Access Compliance Report

Public Rights-of-Way

(Curb Ramps)

Intersection ID: 10025963	Main Street: ELM_LN	Cross Street: N/A	Location: NW
ADA ID: 5DA31F0620E6	Ramp Type: Para	Initial Pass/Fail: Fail	Overall Compliance: No
Severity Score: 12.5			
Codes/Mitigation Info/Possible Solution		Field Measurements/Component Compliance

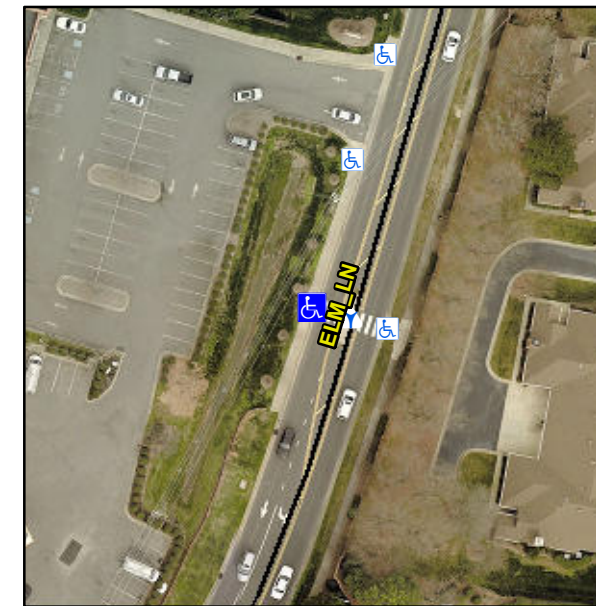
R304.3.2

Compliance	Description	Data	Compliance	Description	Data
N/A	Ramp Length LT (in)	73.0	N/A	Ramp Length RT (in)	70.0
Yes	Ramp Width LT (in)	60.0	Yes	Ramp Width RT (in)	60.0
Yes	Ramp Slope LT (%)	5.8	No	Ramp Slope RT (%)	8.5
Yes	Ramp XSlope LT (%)	0.8	Yes	Ramp XSlope RT (%)	1.9
N/A	Landing Length (in)	N/A	N/A	DWS Provided?	N/A
N/A	Landing Width (in)	N/A	N/A	DWS Contrast?	N/A
N/A	Landing Slope (%)	N/A	N/A	DWS Length (in)	N/A
N/A	Landing X Slope (%)	N/A	N/A	DWS Full Width?	N/A
N/A	Landing Curb? (Y/N)	N/A	N/A	DWS Offset (in)	N/A
N/A	Shared Landing?	N/A			
N/A	Gutter Ponding?	N/A	N/A	Gutter Slope (%)	N/A
N/A	Gutter Lip Ht (in)	N/A	N/A	Gutter X Slope (%)	N/A
N/A	Painted X Walk1?	Yes	N/A	Painted X Walk2?	N/A
	X Walk 1 Direction	To SE		X Walk 2 Direction	N/A
N/A	X Walk 1 Width (in)	122.0	N/A	X Walk 2 Width (in)	N/A
	X Walk 1 Slope (%)	7.4		X Walk 2 Slope (%)	N/A
	X Walk 1 X Slope (%)	0.8		X Walk 2 X Slope (%)	N/A
N/A	Ramp inside XWalk1?	Yes	N/A	Ramp inside XWalk2?	N/A

Remove & Replace Entire Ramp.
